# Access Compliance Report

## Public Rights-of-Way

### (Curb Ramps)

Intersection ID: 47846	Main Street: ALVARADO_WY	Cross Street: STONE_PORCH_RD	Location: NE
ADA ID: 3E700C660799	Ramp Type: Perp	Initial Pass/Fail: Fail	Overall Compliance: No
Severity Score: 8.75			
Codes/Mitigation Info/Possible Solution		Field Measurements/Component Compliance

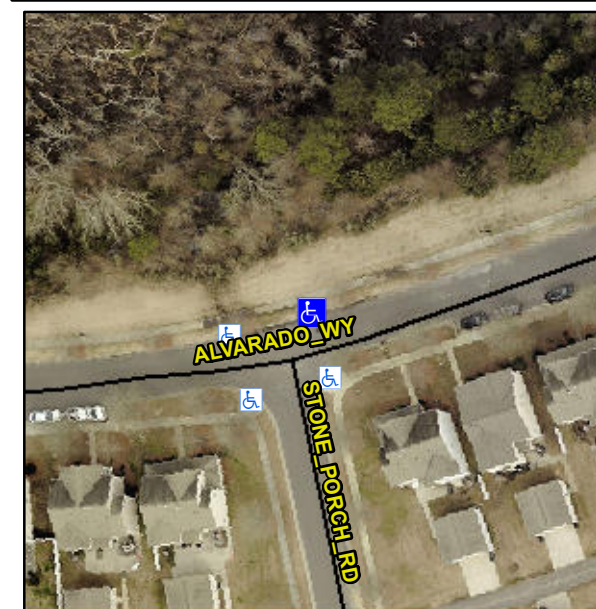
**Not Found, R304.5.1**

Compliance	Description	Data	Compliance	Description	Data
N/A	Ramp Length (in)	133.0	Yes	Ramp Slope (%)	6.5
No	Ramp Width (in)	46.5	Yes	Ramp XSlope (%)	1.6
N/A	Flare Type LT	N/A	N/A	Flare Type RT	N/A
N/A	Flare Slope LT (%)	N/A	N/A	Flare Slope RT (%)	N/A
N/A	Flare Traversable LT?	N/A	N/A	Flare Traversable RT?	N/A
N/A	Landing Length (in)	N/A	N/A	DWS Provided?	N/A
N/A	Landing Width (in)	N/A	N/A	DWS Contrast?	N/A
N/A	Landing Slope (%)	N/A	N/A	DWS Length (in)	N/A
N/A	Landing X Slope (%)	N/A	N/A	DWS Full Width?	N/A
N/A	Landing Curb? (Y/N)	N/A	N/A	DWS Offset (in)	N/A
N/A	Shared Landing?	N/A			
N/A	Gutter Ponding?	N/A	N/A	Gutter Slope (%)	N/A
N/A	Gutter Lip Ht (in)	N/A	N/A	Gutter X Slope (%)	N/A
N/A	Painted X Walk1?	No	N/A	Painted X Walk2?	N/A
	X Walk 1 Direction	To S		X Walk 2 Direction	N/A
N/A	X Walk 1 Width (in)	N/A	N/A	X Walk 2 Width (in)	N/A
	X Walk 1 Slope (%)	1.7		X Walk 2 Slope (%)	N/A
	X Walk 1 X Slope (%)	1.0		X Walk 2 X Slope (%)	N/A

**Remove & Replace Entire Ramp.**
